Draft revised International Standard for Tracking and Tracing on Inland Waterways (VTT) (Resolution No. 63)

Addendum

Transmitted by the Chair of the VTT Expert Group¹

International Standard Technical Specifications for Vessel Tracking and Tracing on Inland Waterways Systems in Inland Navigation

D.2 Inland waterway static ~~ship~~ vessel data

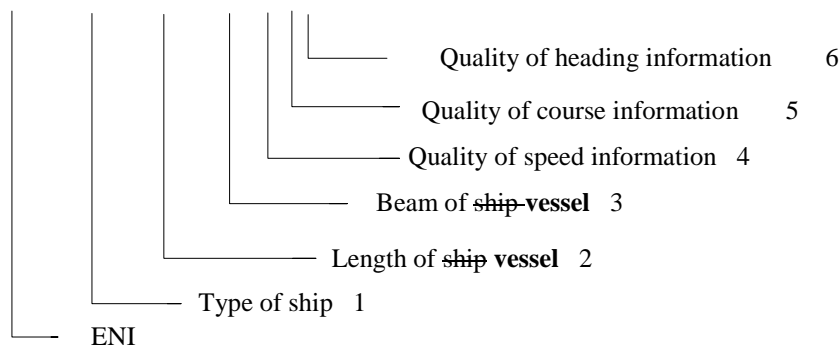
This sentence is used to enter inland navigation static ~~ship~~ vessel data into an Inland AIS unit. For setting the inland static ~~ship~~ vessel data the sentence \$PIWWSSD with the following content is ~~proposed~~ used:

D.3 Inland waterway voyage-related vessel ~~ship~~ data

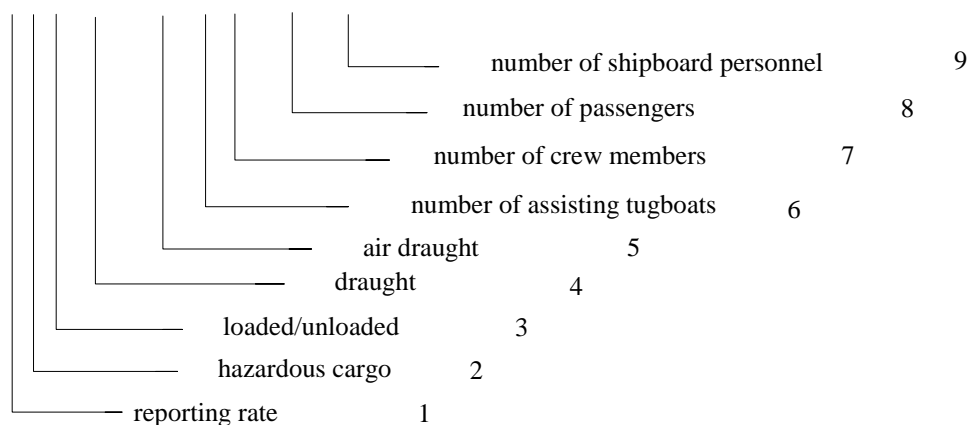
This sentence is used to enter inland navigation voyage-related ~~ship vessel~~ data into an Inland AIS unit. For setting the inland voyage-related data the sentence \$PIWWIVD with the following content is ~~proposed~~ used:

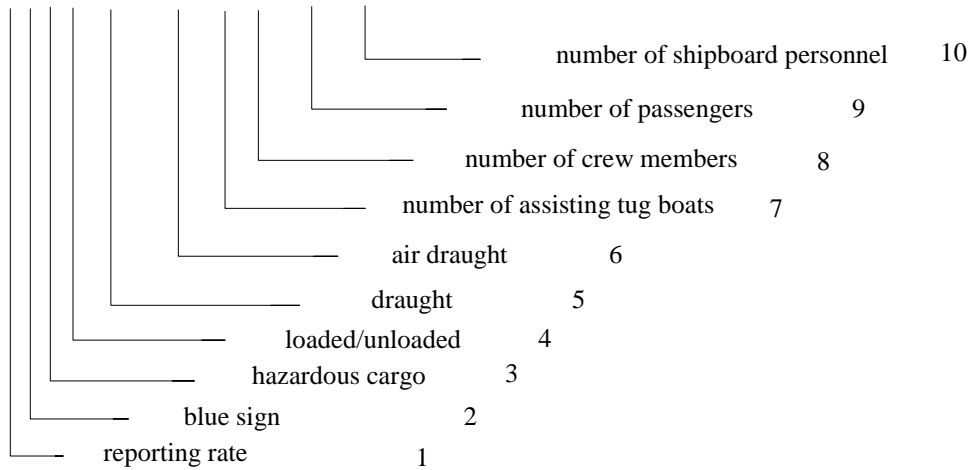
sign” which may raise conflicts with the parameter field “regional application flags” in the \$--VSD sentence according to IEC 61162-1:VSD-AIS voyage static data.

It should no longer be implemented in new AIS transponders. However, for compatibility reasons, it should be supported by external applications.
